**Highview Estates
(Sub.)**

SUBJECT: HIGHVIEW ESTATES SUBDIVISION
NWPB APP. NO. 01-31

**TOWN OF NEW WINDSOR
PLANNING BOARD
REVIEW COMMENTS**

PROJECT NAME: HIGHVIEW ESTATES MINOR SUBDIVISION
PROJECT LOCATION: LINDEN AVENUE (BEAVER DAM LAKE AREA)
SECTION 62 – BLOCK 3 – LOT 4
PROJECT NUMBER: 01-31
DATE: 11 APRIL 2001
DESCRIPTION: THE APPLICATION PROPOSES THE SUBDIVISION OF THE 0.9 +/-
ACRE PARCEL INTO TWO (2) SINGLE-FAMILY LOTS. THE PLAN IS
BEING REVIEWED ON A CONCEPT BASIS ONLY.

PUMP STATION DETAIL

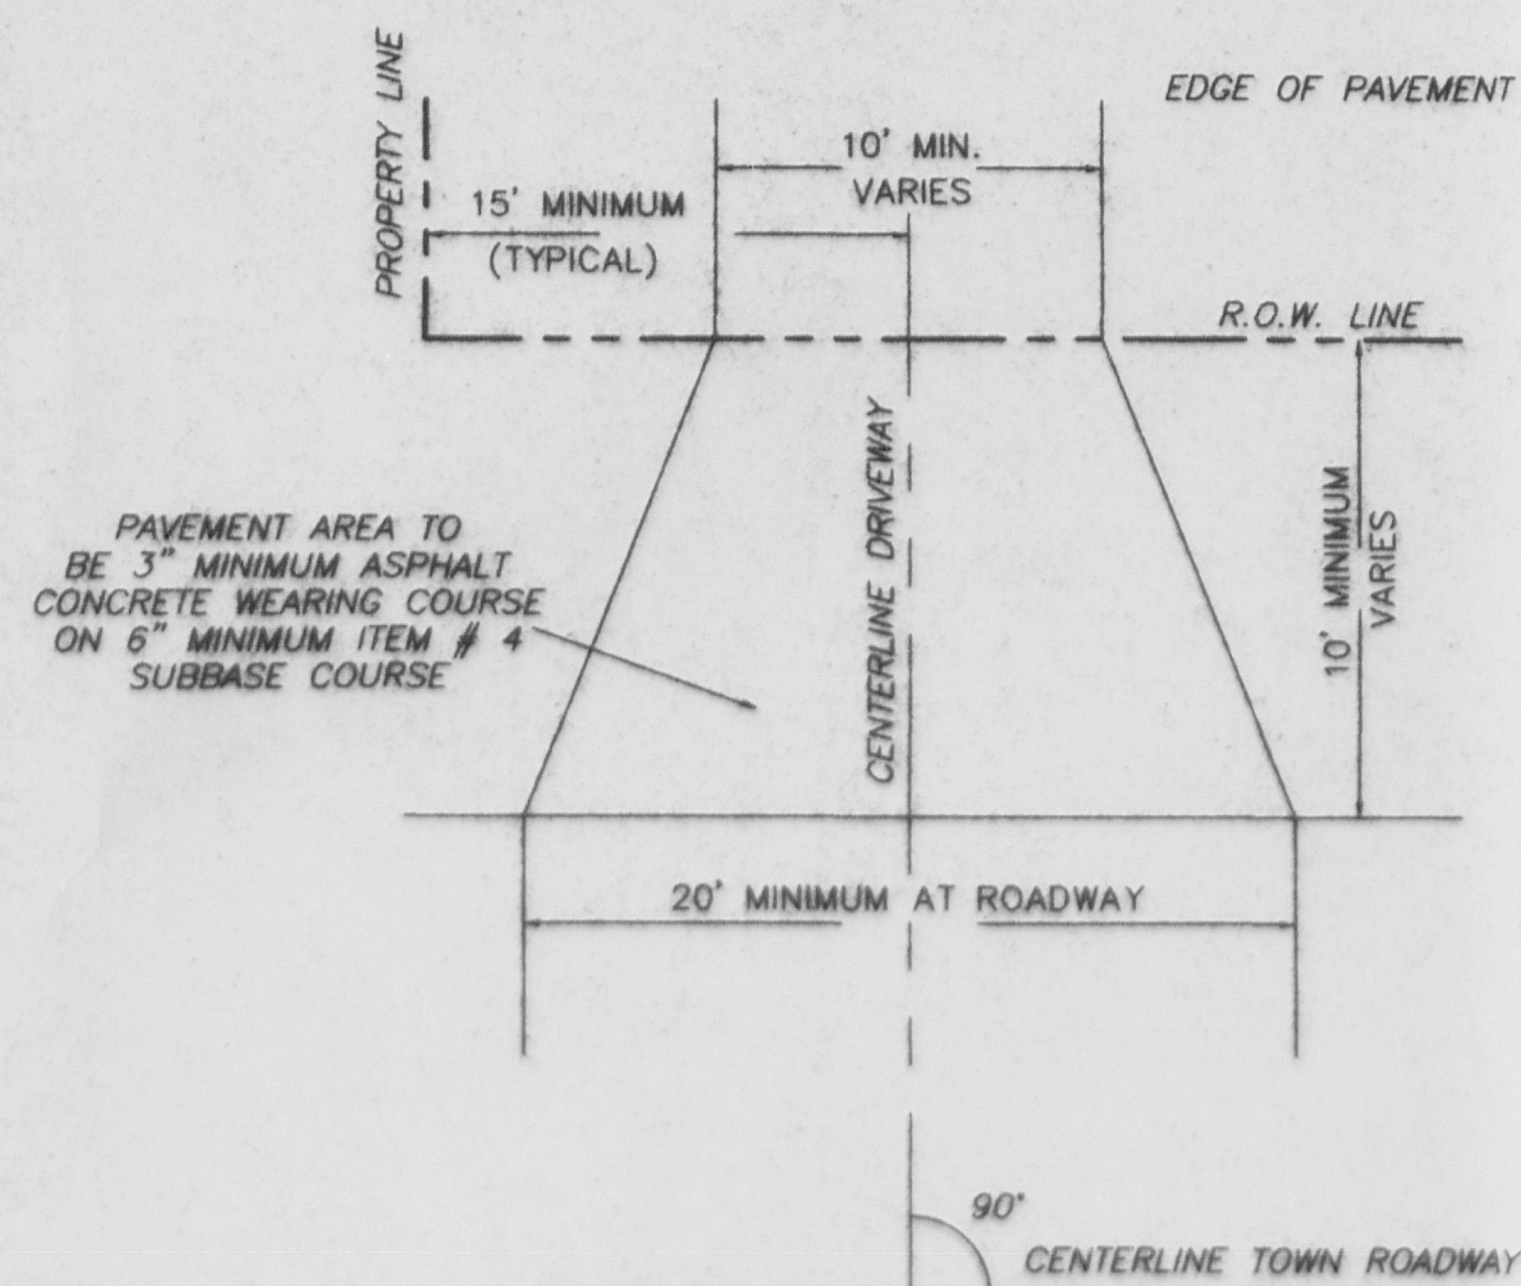
3. With regard to the individual sanitary pump ejector stations, please note the following:
 - a. The applicant should be aware that the individual grinder pump stations will be private and will not be maintained by the Town.

- b. The pump wet well should be sized to provide a minimum capacity of 24 hours in the event of a power failure.
 - c. A high level alarm should be installed in the garage of each residence. The plan note currently states the alarm will be in the “store”?

- d. The plan indicates a Bilco hatch at the top of the wet well. Perhaps a manhole cover would be more appropriate (and less costly).
 - e. The plans note that two pumps are in each station. Will these be automatic alternation?

3. With regard to the individual sanitary pump ejector stations:
 - a. The applicant is aware that the individual grinder pump stations will be private and will not be maintained by the Town.

- b. The pump wet well has been sized to provide a minimum capacity of 24 hours in the event of a power failure.
 - c. A high level alarm will be installed in the garage of each residence.

- d. The plan has been revised to show a manhole cover at the top of the wet well.
 - e. A single pump is shown for each station with a shutoff valve on the discharge line.

WATER SERVICE DETAIL

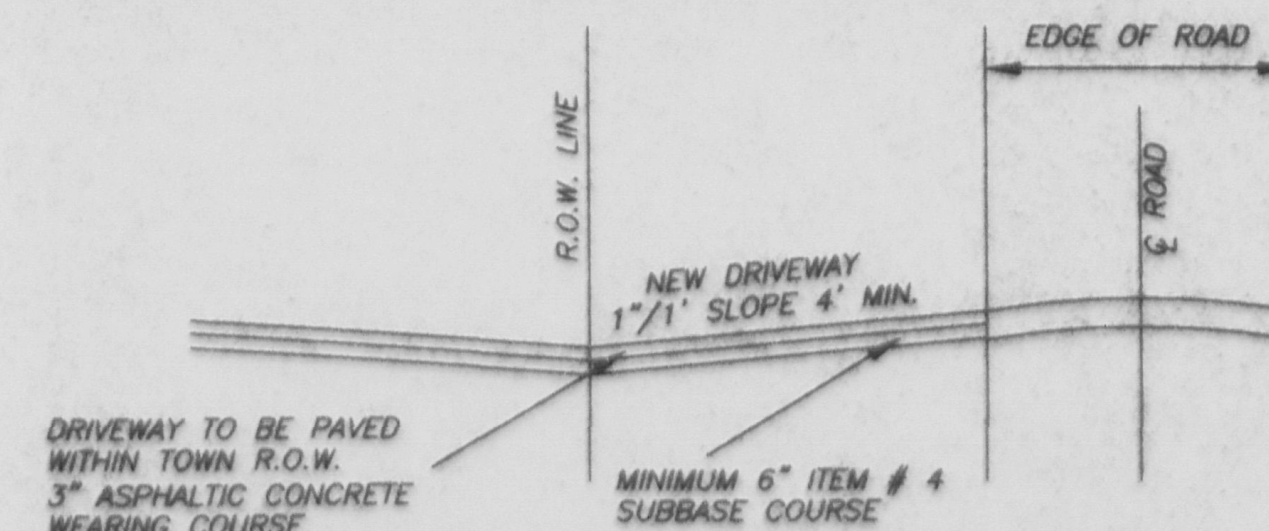
2. The application is based on the availability to connect to the Town sewer and to the private water system in the area. We should have a response on file from the Town Sewer Dept., and we should have the applicant obtain a letter from the operator of the water system indicating they will provide service, have adequate capacity and is approved by the OCDOH for additional connections.

1. No comment needed.
2. The Beaver Dam Lake Water Corporation has agreed to provide water service for both homes. Their requirements have been added to sheet #2 of the plans. See enclosed letter.
